### **15.5.U.1 Chassis Support bars**

In 2019 all chassis will be required to have additional bars installed to support and decrease the span between the front and rear uprights in the drivers area. The new support bars must be in addition to the front and rear uprights. Any attempts to manipulate the front and rear uprights to conform to these measurement will not be allowed at the discretion of World of Outlaws Series Officials. These additional bars will be minimum 1.375 X .083 ASTM4130 normalized steel or equivalent material as per World of Outlaws current rule 15.5.U.

Diagram 16.12.1  
By Tom Devitt

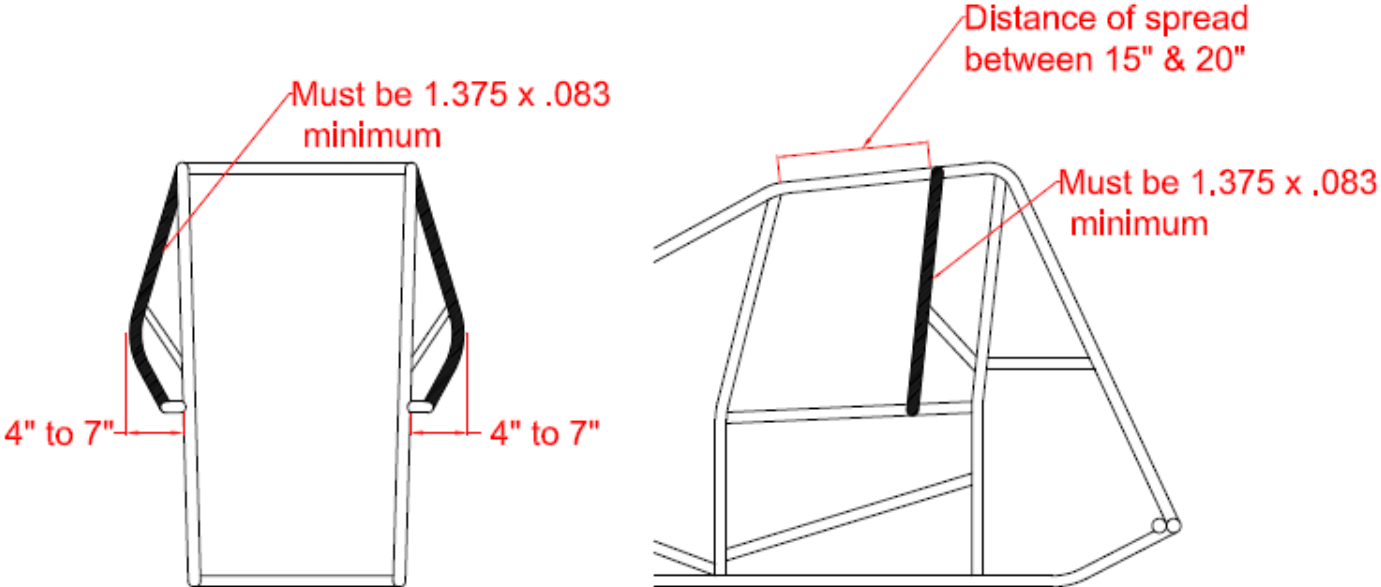
1. Support bar may be designed similar to what was known as a "safety bar". It must be attached to the top rail at a point 15" to 20" from the rear of the front upright. It must attach to the hip rail and have a gusset attached to the rear upright near a point opposite of the rear brace/shock mount bar. The curve must be between 4" and 7" measured from outside of the rear upright tube to the outside of the support bar. See Diagram #16.12.1

Diagram 16.12.2  
by Tom Devitt

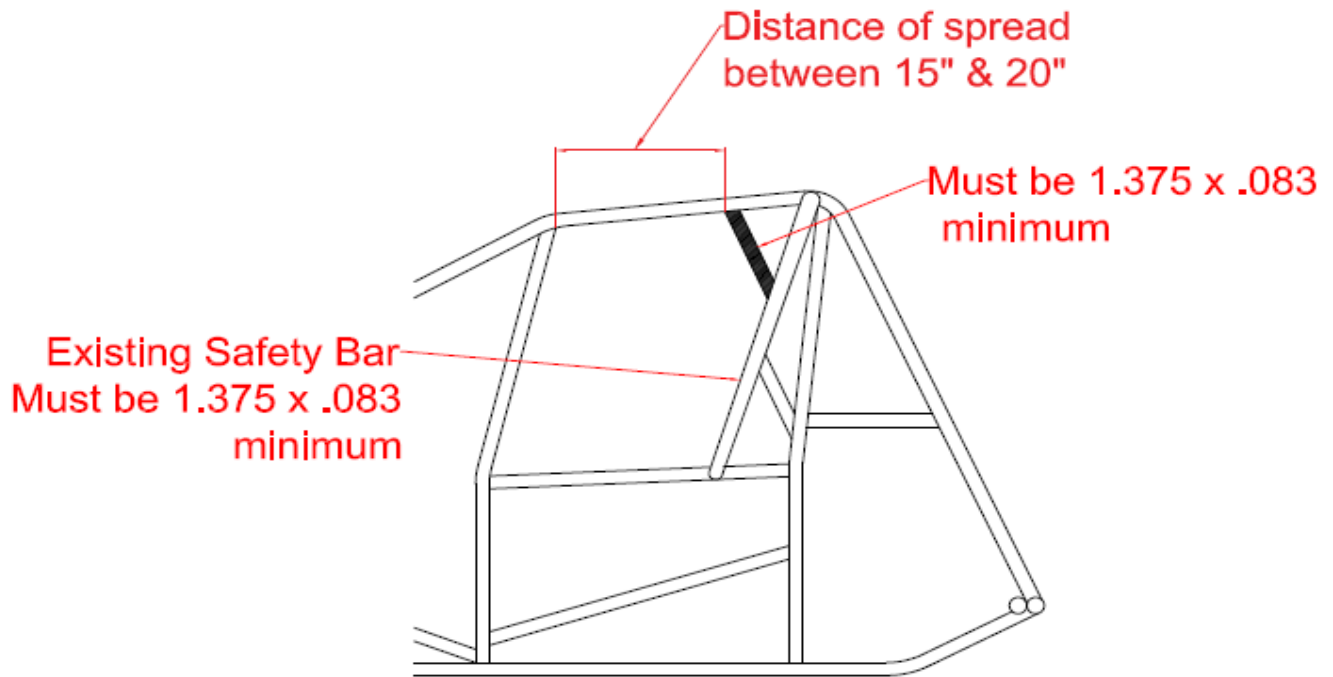
2. Existing chassis with a left side support bar installed (formerly called safety bar) that do not meet the option one specification above, may add a gusset that attaches to the top rail 15" to 20" from the rear of the front upright and angle to the support bar. The existing support bar tubing must meet the minimum as described above (1.375 X .083 ASTM4130 normalized steel or equivalent material). See Diagram #16.12.2

Drawing 16.12.3  
By Tom Devitt

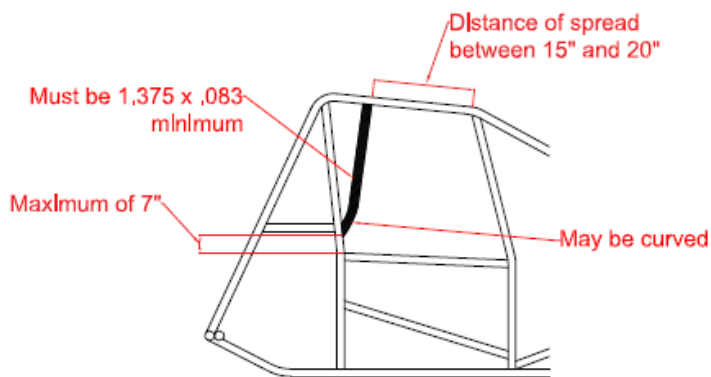
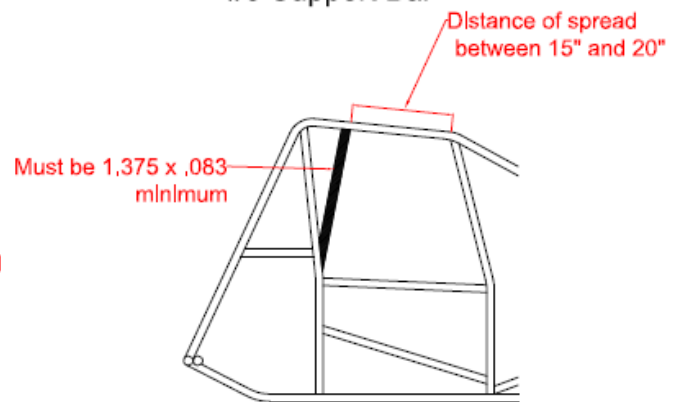
3. A support bar may be added to the top rail at a point 15" to 20" from the rear of the front upright and to the rear upright near a point of the rear brace / shock mount bar but no higher than 7" above the hip rail. This bar may have a slight curve near the rear upright to accommodate elbow room and ease of fitment. See diagram #16.12.3

## Replace 15.5.V with the following

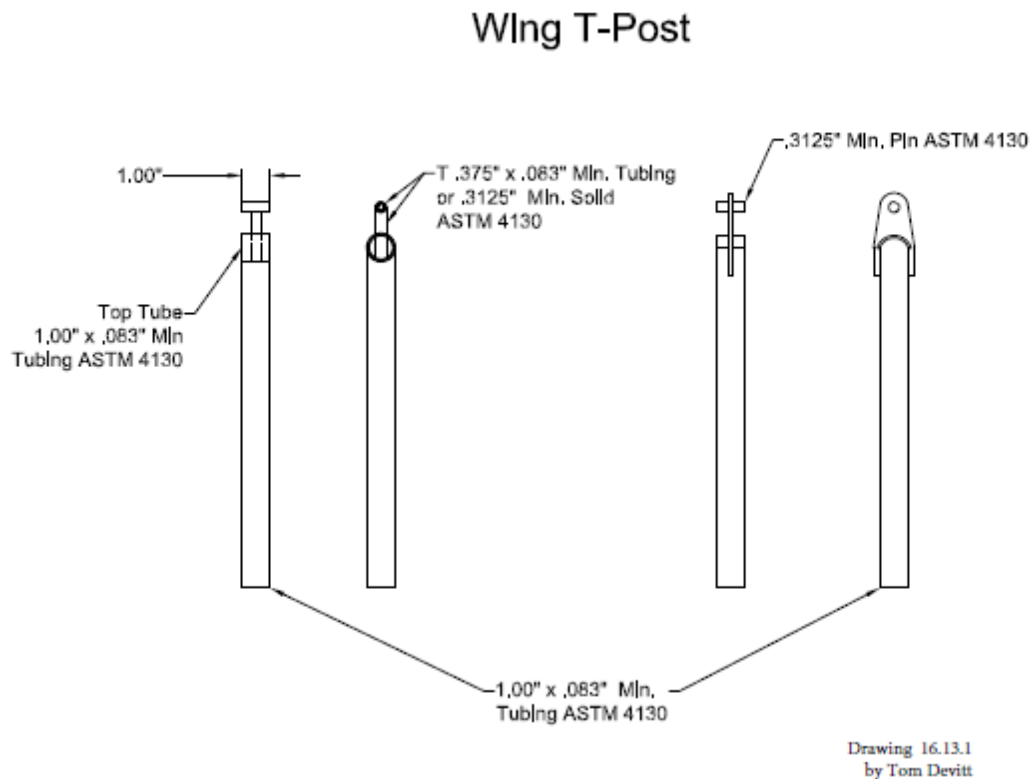
Slip-tubing is not allowed in the chassis construction. Any existing slip-tubing must be replaced or welded. Clamped or bolted slip tube joint will no longer be allowed.
